**STATE OF TENNESSEE
DEPARTMENT OF TRANSPORTATION
DESIGN DIVISION**

INSTRUCTIONAL BULLETIN NO. 14-05

Regarding Revised Standard Drawings

Effective for the August 29th Letting (June 18th turn-in), the following Standard Drawings are revised and Section V of the Design Guidelines is revised for this update.

30'-50' STANDARD LIGHT FOUNDATION DETAIL IN ROCK

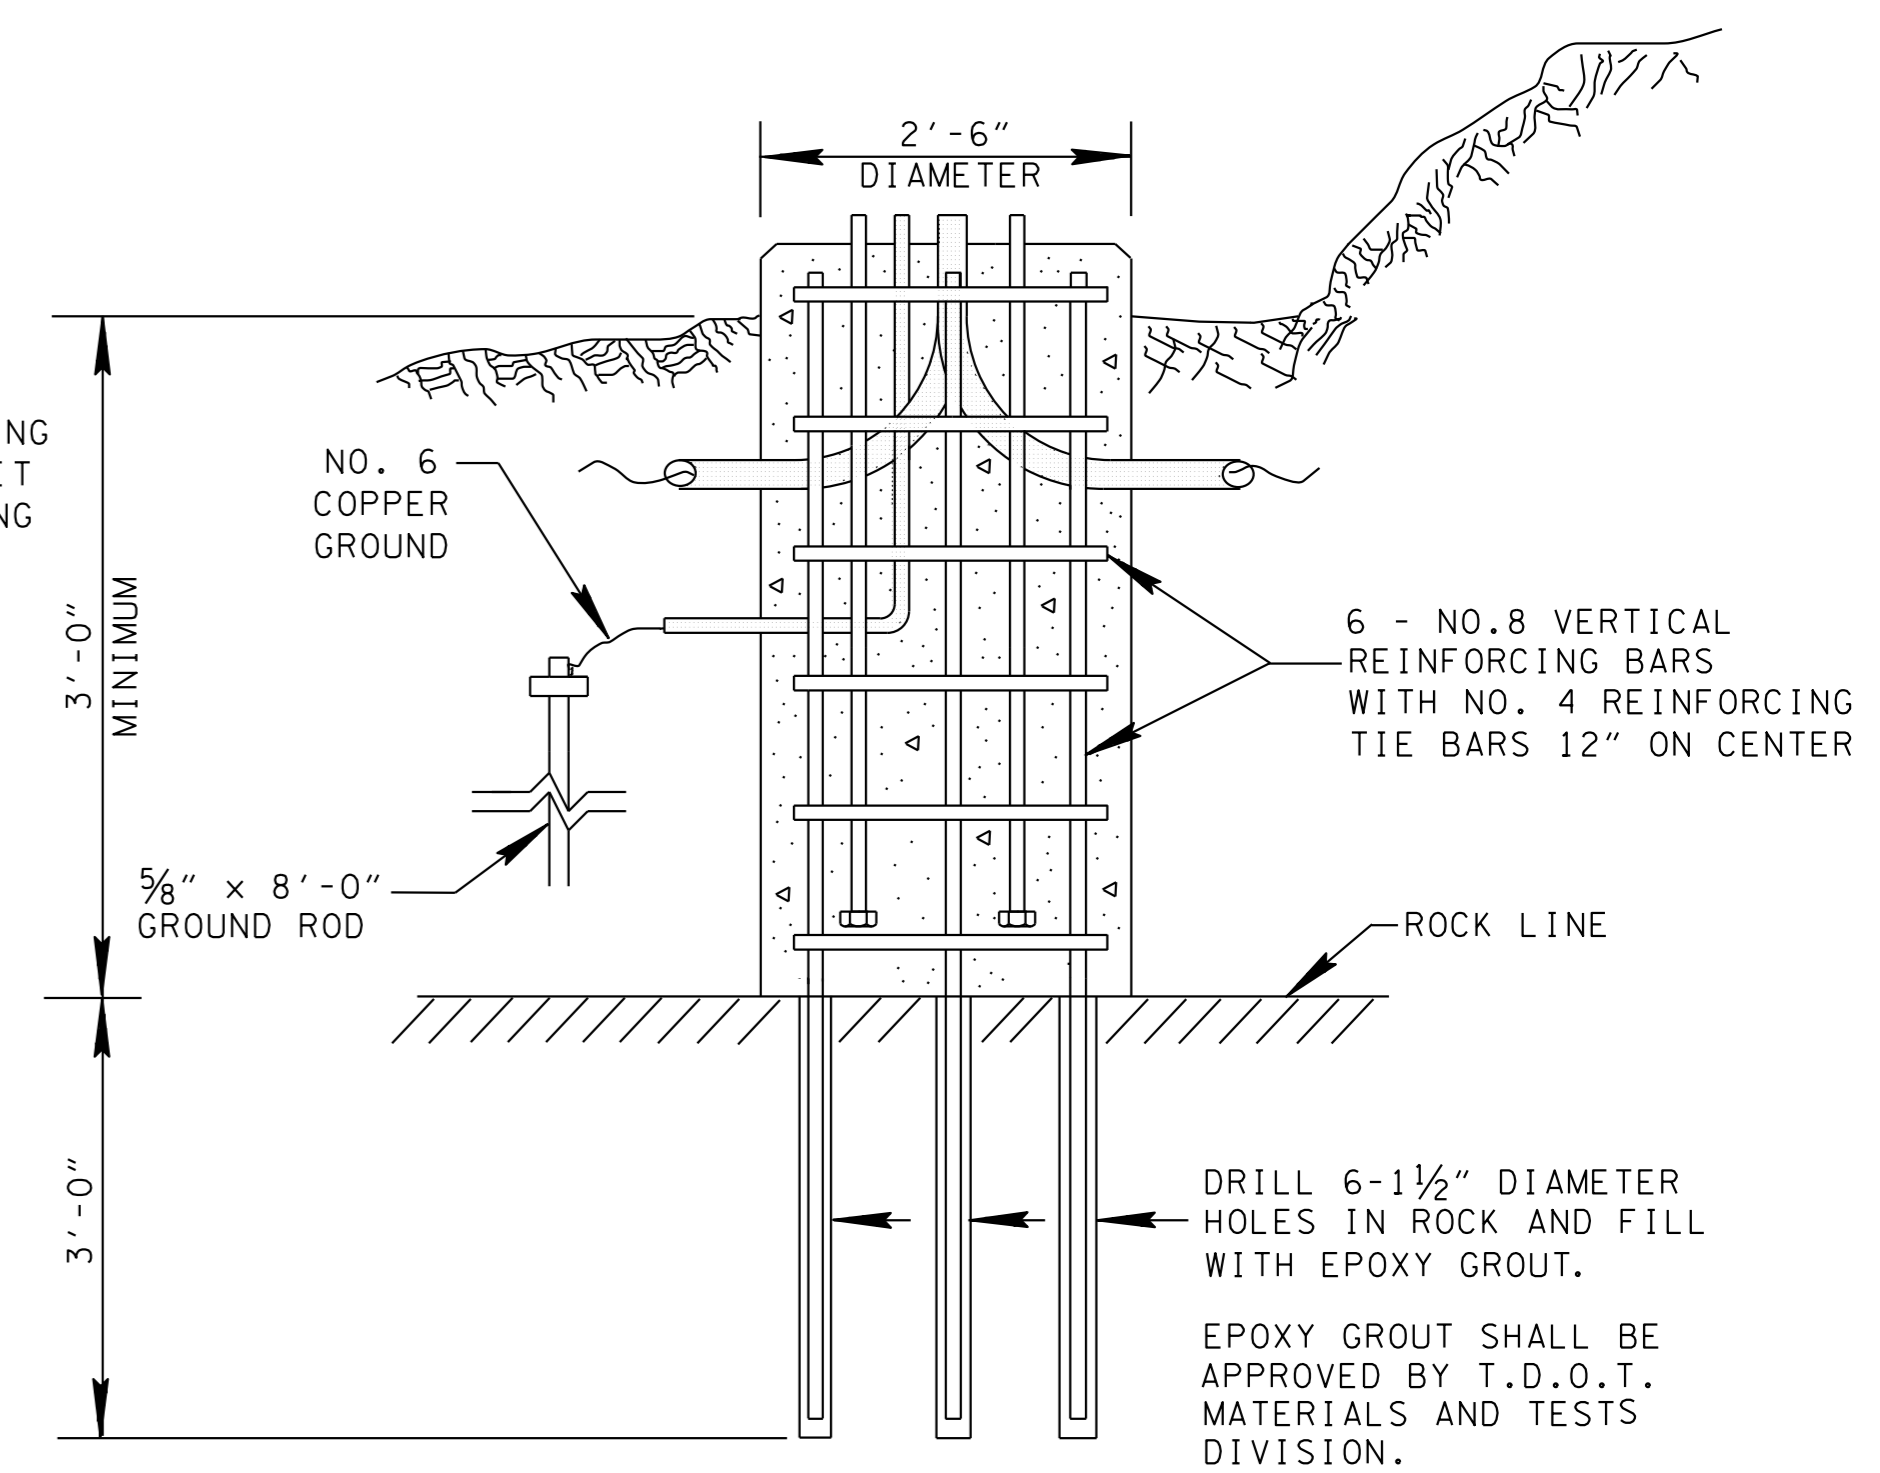
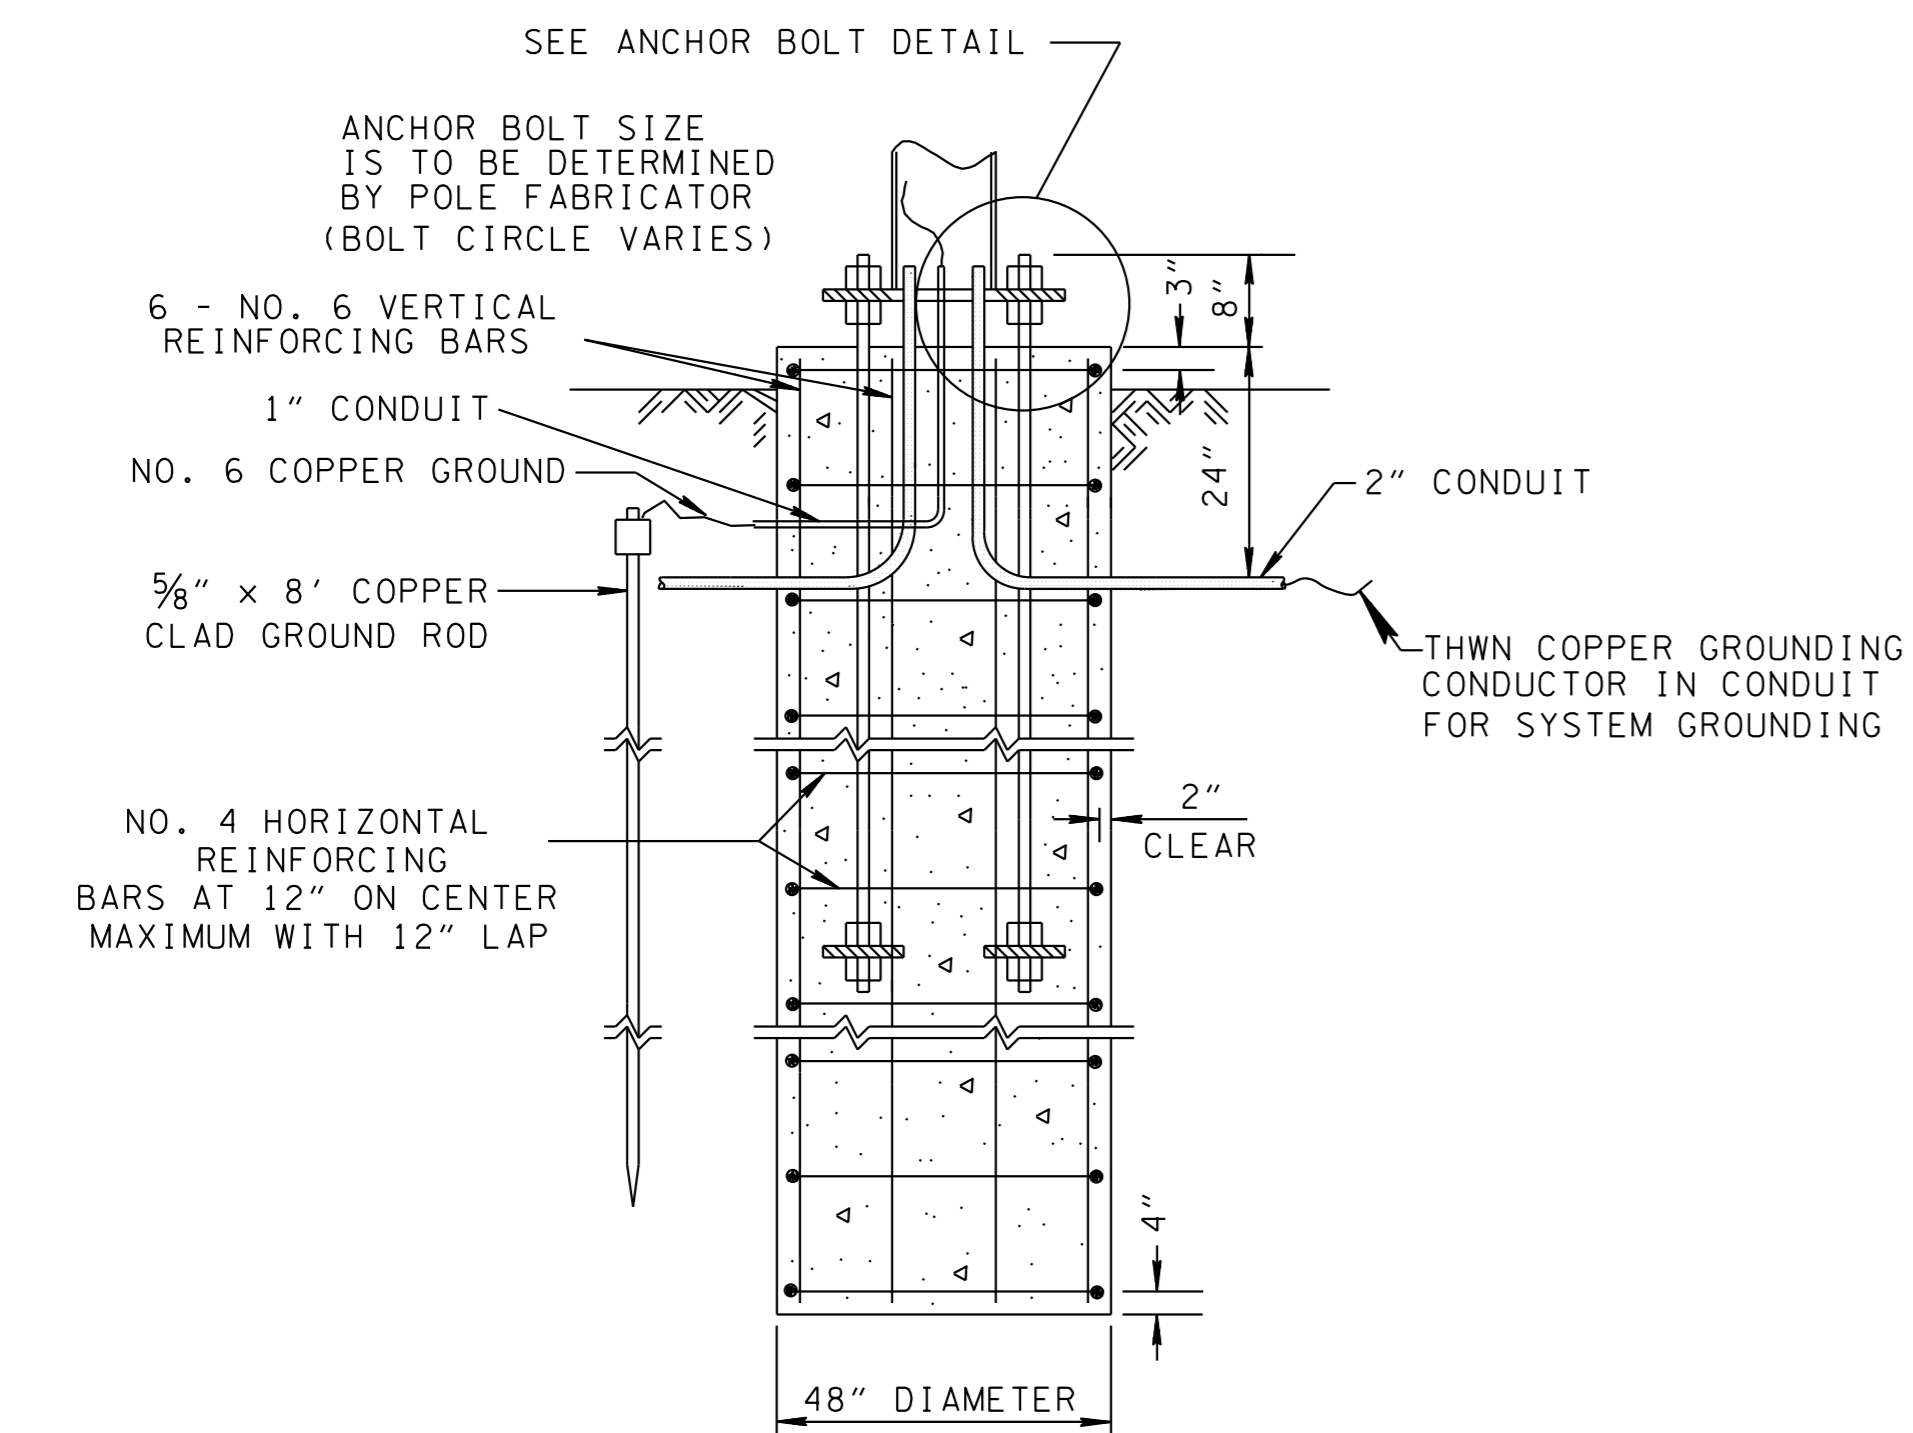
- REV. 11-12-93: NEW SHEET TRANSFERRED INFORMATION FROM T-L-1. ADDED METAL FOUNDATION DETAIL ALTERNATE.
- REV. 5-27-94: ADDED TABLE FOR HIGH MAST FOOTING AND GROUNDING CONDUCTOR SIZE.
- REV. 10-26-95: MODIFIED DESCRIPTION OF REINFORCING STEEL. CHANGED SIZE OF GROUND ROD ON HIGH MAST FOUNDATION DETAIL.
- REV. 12-16-03: DELETED GROUNDING CONDUCTOR CHART. ADDED NOTE E.
- REV. 7-29-04: CHANGED DRAWING NO. FROM T-L-1A TO T-L-1. ADDED GENERAL NOTE (E) DELETED GROUNDING CONDUCTOR SIZE TABLE.
- REV. 02-15-07: ADDED ANCHOR BOLT DETAIL. NOTES AND NOTE (E) AND (F) ADDED.
- REV. 12-4-13: CHANGED ANCHOR BOLTS TO THREADED. ADDED BEARING AREA TABLE.
